## INDIANA DEPARTMENT OF TRANSPORTATION

# FINAL DRAFT MINUTES

## November 17, 2023, Standards Committee Meeting

RE: Minutes from the November 17, 2023, Standards Committee Meeting

724-B-147d ALTERNATE SS JOINT (proposed to delete)

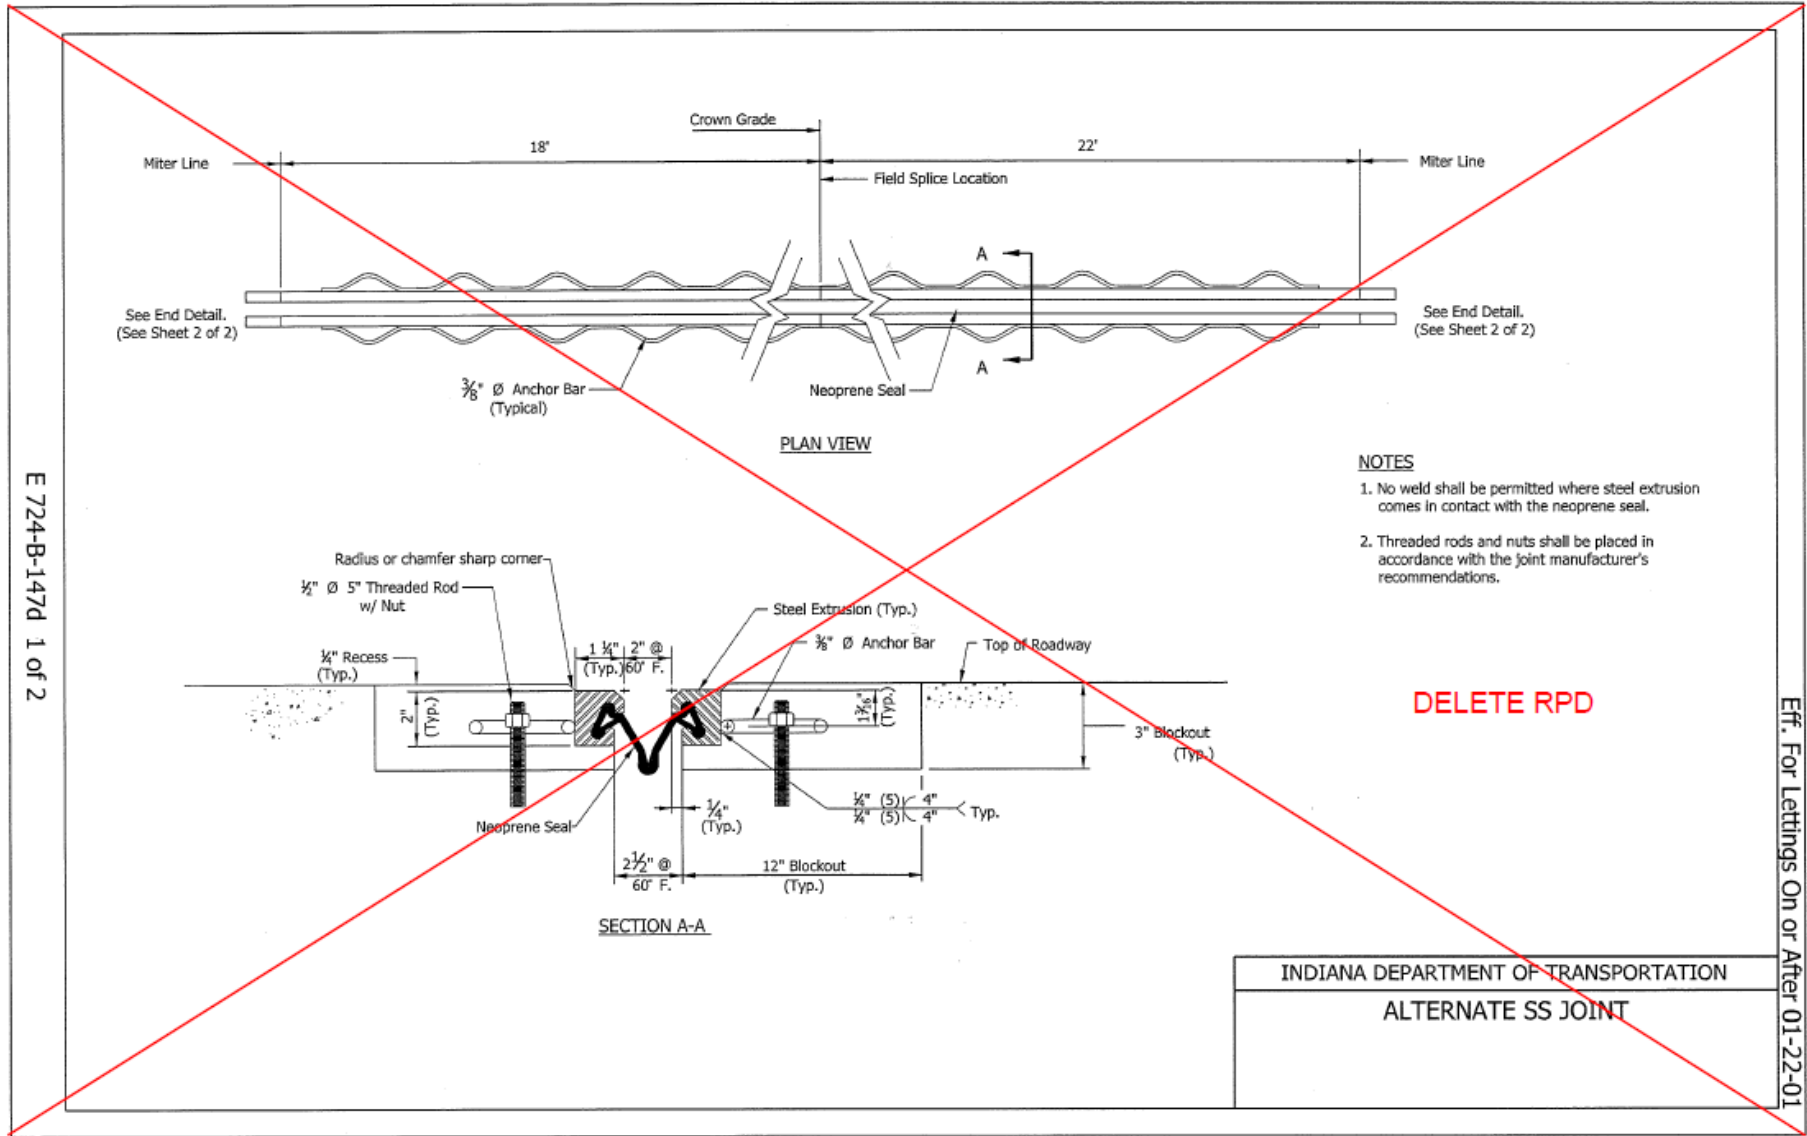
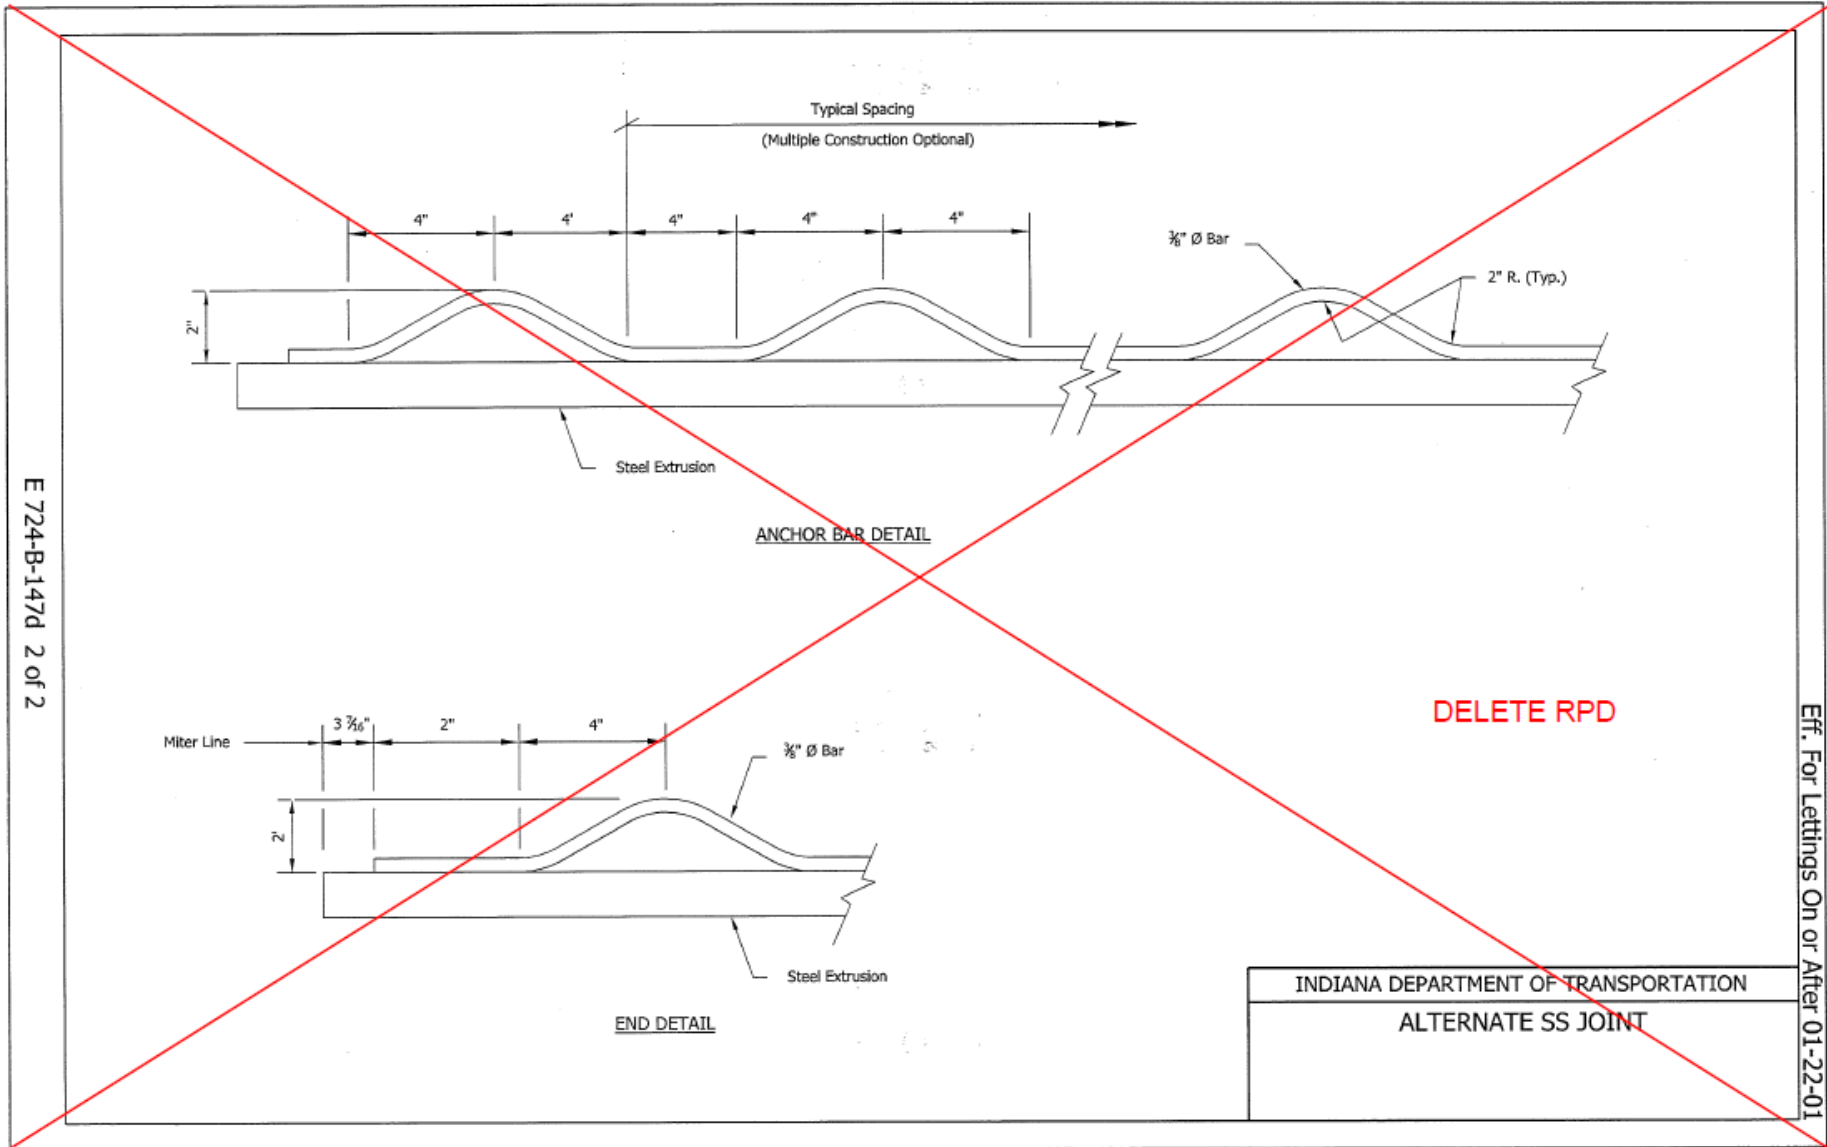
PROBLEM(S) ENCOUNTERED: The Alternate SS Joint, as shown on recurring plan detail RPD 724-B-147d, has experienced early failures at several locations.

Provide any further information as to why this proposal should be placed on the Standards Committee meeting Agenda: This joint type has proven to have a short service life and shouldn't be used on future projects.

Mr. White introduced and presented this item explaining that the Alternate SS Joint, as shown on recurring plan detail RPD 724-B-147d, has experienced early failures at several locations.

PROPOSED SOLUTION: Eliminate RPD 724-B-147d

Mr. White therefore proposed to eliminate RPD 724-B-147d.

E 609-RCBA-04 REINFORCED CONCRETE BRIDGE APPROACH SECTION, PAVEMENT LEDGE, AND BAR BENDING DETAILS (shown markups)

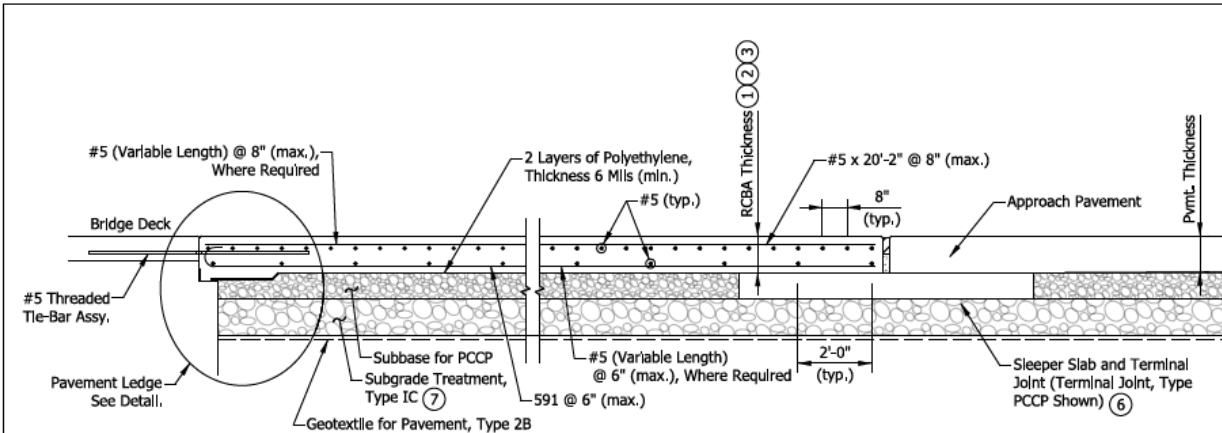
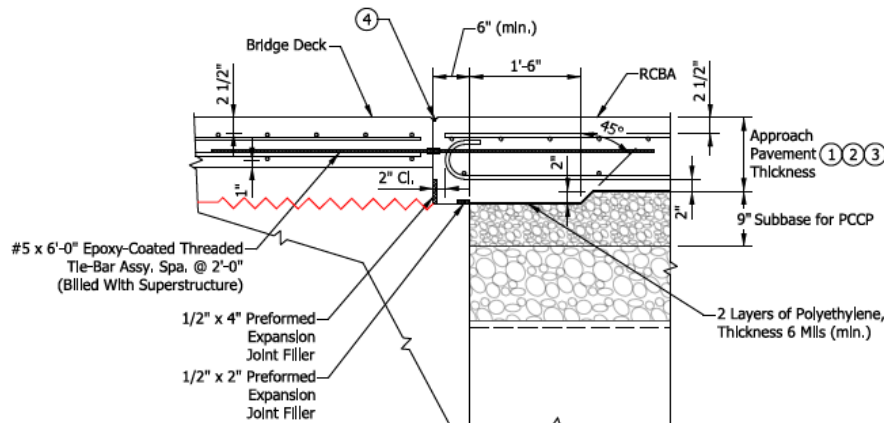
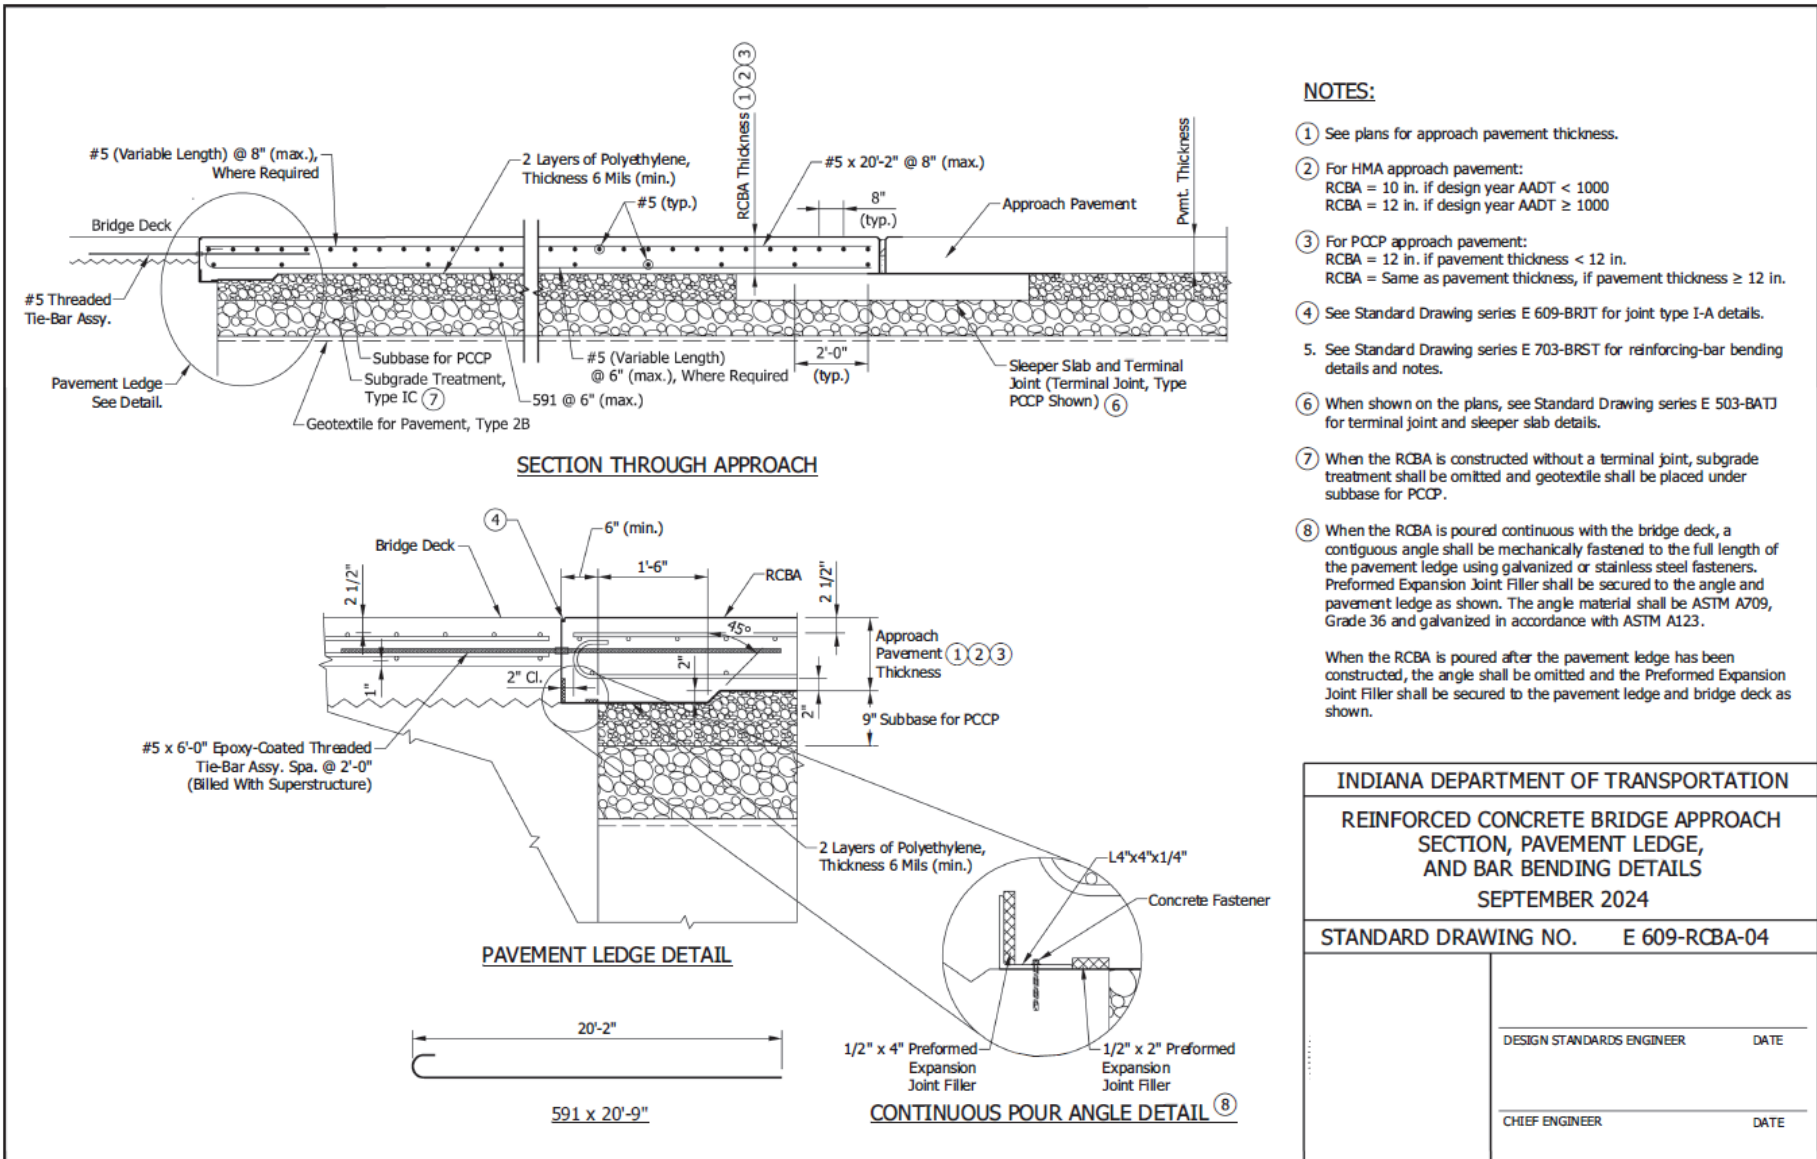
Prior to [Construction Memo 07-23](#), concrete bridge decks and approaches could be poured continuously. Since after the memo, bridge decks and approaches were required to be poured separately due to the random cracking occurring around the 1-A joint, both during and after the pour. This caused the need for repairs that are both costly for the Contractor and detrimental to the expected life of the concrete.

As construction techniques and methods improved over the years, Industry Leadership expressed interest again in pouring the bridge deck and approaches monolithically together. As a result, the Department facilitated a pilot program for the past two years to review the impacts of the continuous deck pours. The pilot projects concluded that this method promotes a smoother ride between the deck and approach transition and eliminates two cold joints. Further, this method is quicker and more cost effective.

This item was introduced and presented by Mr. Novak who stated that prior to Construction Memo 07-23, concrete bridge decks and approaches could be poured continuously, as explained on the proposal sheet.

A specification change would allow the Designer of Record to review the Contractor's bridge deck pour sequence and determine if the structure can be poured monolithically. Determining factors include pouring the first span in less than 3.5 hours and the skew of the structure to be less than or equal to 45 degrees. A Design Memo is planned to be published to convey changes to the IDM and Bridge Design Aid 404-01. Furthermore, the revised Standard Drawings, E 609-RCBA-04, includes the requirements for an embedded steel angle component, that will keep the preformed expansion joint filler in place at the 1-A joint location across the structure. Further, A Construction Memo is planned to be published to supersede CM 07-23.

Preformed Expansion Joint Filler shall be secured to the angle and pavement ledge as shown. The angle material shall be ASTM A709, Grade 36 and galvanized in accordance with ASTM A123. When the RCBA is poured after the pavement ledge has been constructed, the angle shall be omitted and the Preformed Expansion Joint Filler shall be secured to the pavement ledge and bridge deck as shown.
